Subject: Otter Tail Power Company Comments on: Carbon Pollution Emission Guidelines for Existing Stationary Sources: Electric Utility Generating Units; Proposed Rule

Otter Tail Power Company

Proposed Carbon Pollution Emission Guidelines for Existing  
Stationary Sources: Electric Utility Generating Units

79 Fed. Reg. 34,830 (June 18, 2014)  
Docket ID No. EPA-HQ-OAR-2013-0602

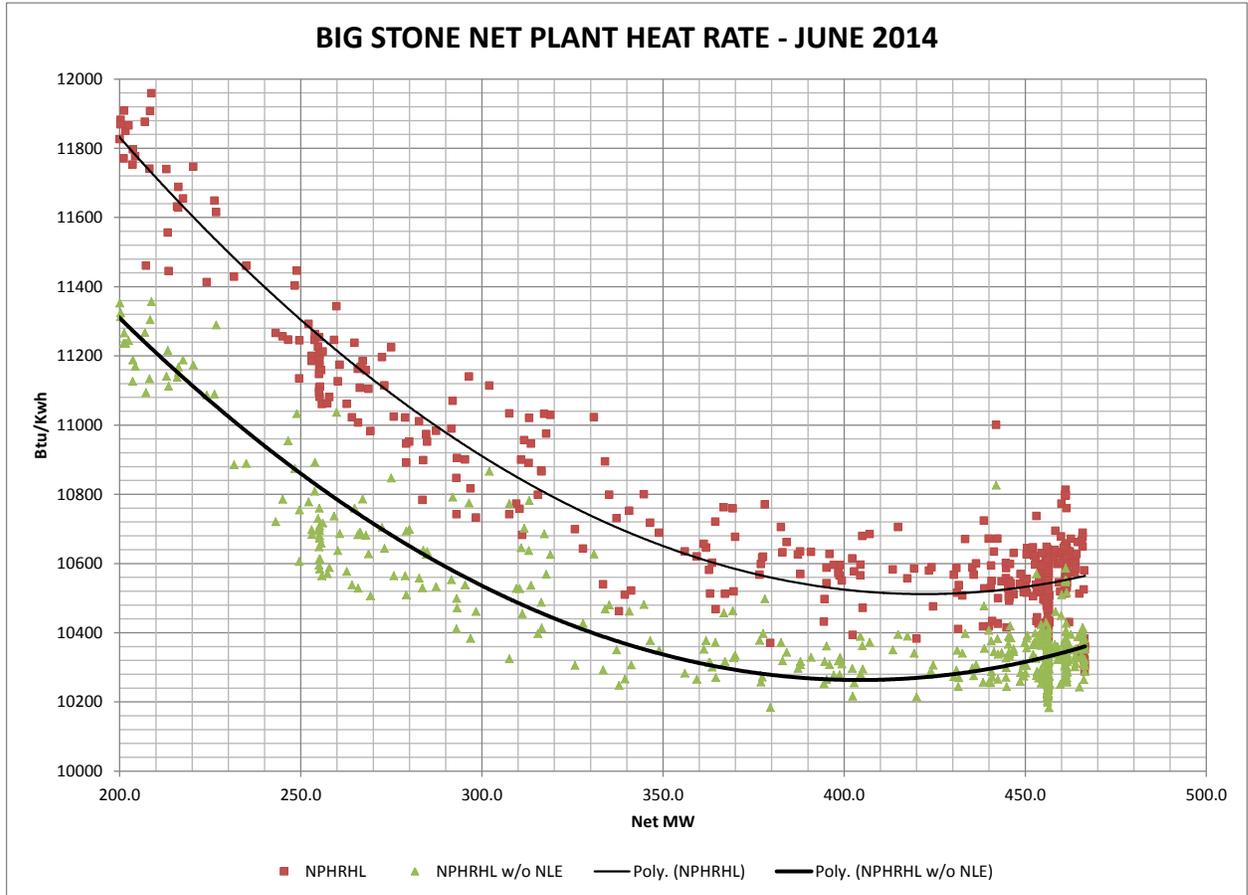
document.<sup>40</sup> The following graph of a typical monthly net plant heat rate chart at Big Stone Plant plainly illustrates the heat rate impact of operating at less than full load. A 50% reduction in normal generation loading results in approximately an 8% degradation in heat rate.<sup>41</sup> Far from affording states flexibility in achieving overall emissions reductions, the proposed rule's Building Blocks interfere with one another, so that meeting the target in one block (e.g., the redispatch target in Building Block 2) makes it impossible to meet the target in another (e.g., the heat rate improvement target in Building Block 1).

<sup>41</sup> At 240 MW the regression line projects a heat rate of 11,400 Btu/kwh as compared to a full load heat rate of 10,560 Btu/kwh.
